From: [REDACTED]
Cc: [REDACTED]; Joanna.Vincent@dft.gov.uk; Adam.Richards@wbd-uk.com
Subject: Statement of Case by Cambridge Ramblers, CSET Public Inquiry
Date: 18 July 2025 05:33:55
Attachments: [eblBhxAppDr59Qr0.png](#)
[Dhr3KdCAQO70muwY.png](#)
[0stvqSmZTPGQcDox.png](#)
[Att1_24-12-02_Initial Comments.doc](#)
[Att2_24-12-06_CSET Comments from Cambridge Ramblers.pdf](#)

Your Ref: TWA/25/APP/01

Statement of Case Cambridge South East Transport (CSET) Public Inquiry, by Cambridge Group of Ramblers' Association

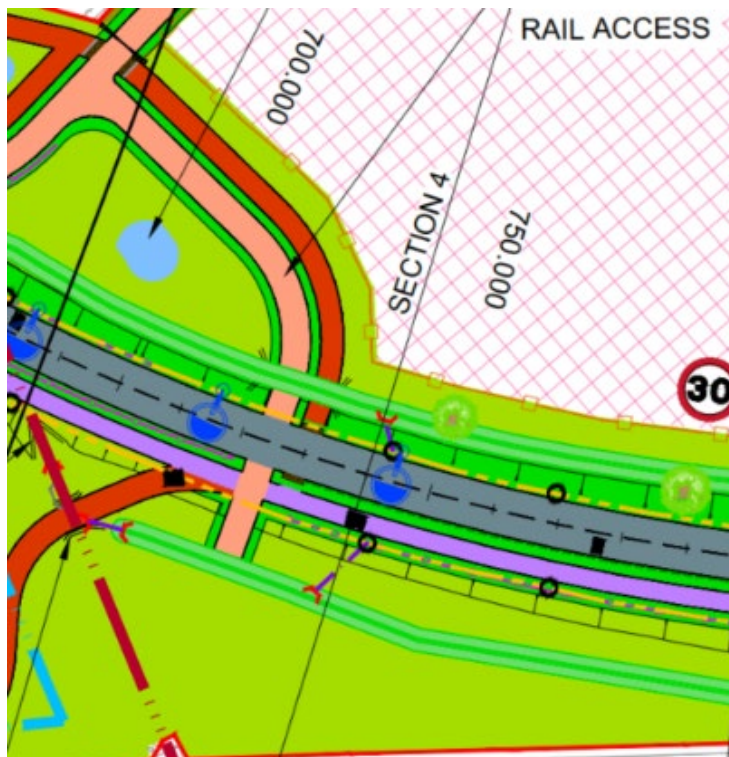
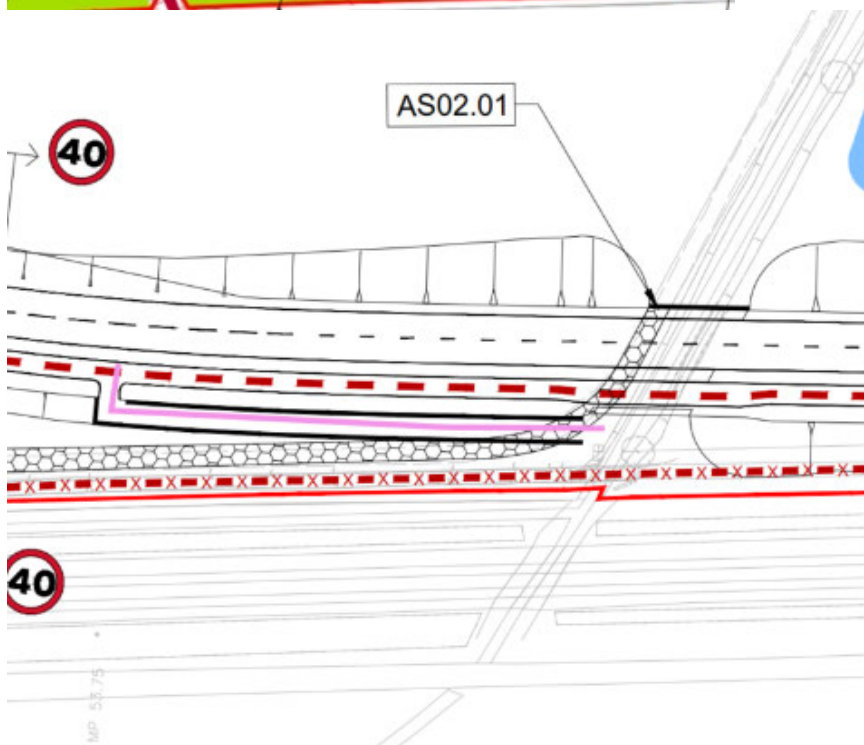
I note that on the previous version of this map (in CSET-11-DO4-00_Rights of Way & Traffic Regulation Plans - Volume 1 dated November 2024) the path from point B to Nine Wells was designated as "Proposed Pedestrian Private Means of Access", but this designation has been removed from the current map (January 2025). I don't understand the significance of this change - can you please explain?

I also note that the plans designate the path from A to C, via Nine Wells, as a "Temporary Diversion". This implies that after the temporary period, it will no longer be accessible. Is this the case? I assume that "diversion" in this context is referring to the DNA path which will be closed. In our opinion it should remain accessible after the temporary diversion; or in other words it should be a permanent diversion (of the DNA path).

As far as I can tell, after the busway is built, walkers from Hobson's Park or the Shelfords can only access Nine Wells if they can cross the busway at points A, B and C. Is this what is planned and will these be safe crossing points for walkers? If not, how can walkers get to Nine Wells? Will the busway be fenced to prevent walkers crossing elsewhere?

I note that on the previous version of this map (in CSET-11-DO4-00_Rights of Way & Traffic Regulation Plans - Volume 1 dated November 2024) the path from point B to Nine Wells was designated as "Proposed Pedestrian Private Means of Access", but this designation has been removed from the current map (January 2025). I don't understand the significance of this change - can you please explain? **The access is still there only the rights have been removed.**

I also note that the plans designate the path from A to C, via Nine Wells, as a "Temporary Diversion". This implies that after the temporary period, it will no longer be accessible. Is this the case? I assume that "diversion" in this context is referring to the DNA path which will be closed. In our opinion it should remain accessible after the temporary diversion; or in other words it should be a permanent diversion (of the DNA path). **The DNA path will be accessible during and after construction. The temporary diversion shown on plans is for DNA path and is for construction sequencing/phasing, so as to maintain accessibility for the DNA path during the construction period. Following completion of the guided busway, the DNA path will be diverted to emergency and maintenance access (active travel path) along the guided bus way route but will still be accessible.**

As far as I can tell, after the busway is built, walkers from Hobson's Park or the Shelfords can only access Nine Wells if they can cross the busway at points A, B and C. Is this what is planned and will these be safe crossing points for walkers? If not, how can walkers get to Nine Wells? Will the busway be fenced to prevent walkers crossing elsewhere? **An uncontrolled pedestrian crossing has been proposed between points A & B, please see the snip below and refer to drawing CSET-12-DP4B-00_Proposed Site Plans. An underbridge crossing is also proposed at point B and is shown on CSET-11-DO4-00_Rights of Way & Traffic Regulation Plans - Volume 1 (snip from plans below). Access Deterrent Planting has been proposed along the guided bus way route and the emergency and maintenance access track.**
